PUBLIC SCHOOL DEVELOPMENT STANDARD ADVISORY COMMITTEE

KIMBALL ELEMENTARY SCHOOL DESIGN DEPARTURE RECOMMENDATIONS

Project #3035786-SD

July 30, 2020

Exhibit 7 Proposed Bicycle Long-Term Bike Storage

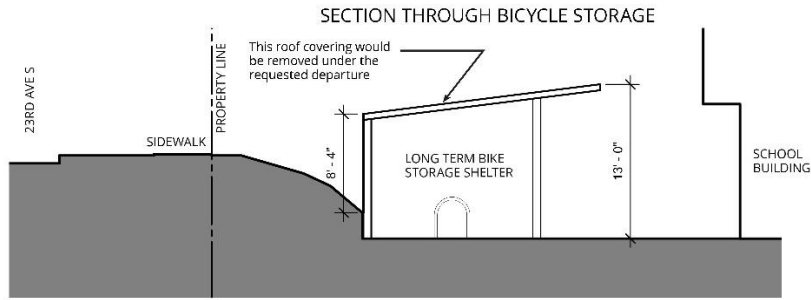
Departure Requested: for a bike storage without any roof covering.

Several comments shared the belief that to encourage students and staff to ride more requires the ability to park their bikes in a place that protects them from the weather and to not cover the long-term bike parking effectively means it is no longer long-term bike parking. The safety concern of people climbing onto the structure should not outweigh the need for secure bike parking and can be dealt with through design and placement of the structure.

Recommendation 5 – That the departure to not provide secure bicycle parking be DENIED as requested by the Seattle Public Schools.

Exhibit 9 Proposed Message Board

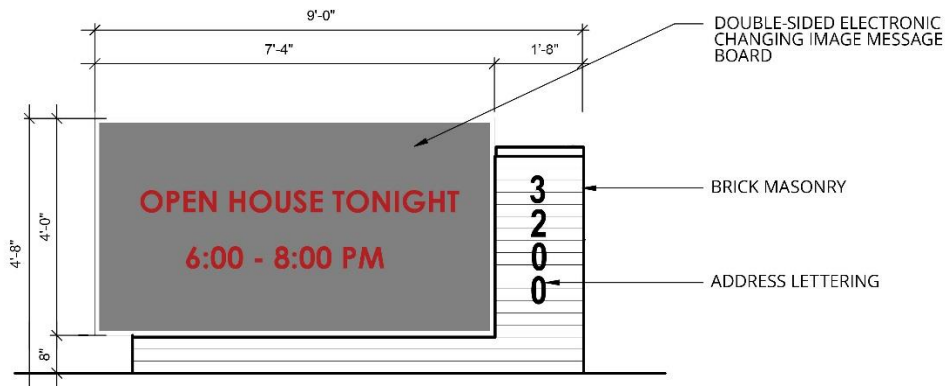
Departure Requested: To install a double-sided, electronic, changing image message board.

One comment was received saying the sign is not a top priority and another comment noting that it will help drive community engagement and awareness of school events. The sign does not appear to be of large concern to the community. The following conditions are recommended to mitigate the perceived impacts on the surrounding neighborhood.

Recommendation 6 – That the departure to allow an electronic message board be GRANTED as requested by the Seattle Public Schools without modification and with the following conditions:

- 1) **The sign must use a monochromatic color scheme**
- 2) **The images on the sign must be non-flashing**
- 3) **Time of use is restricted to 7:00 a.m. - 7:00 p.m.**
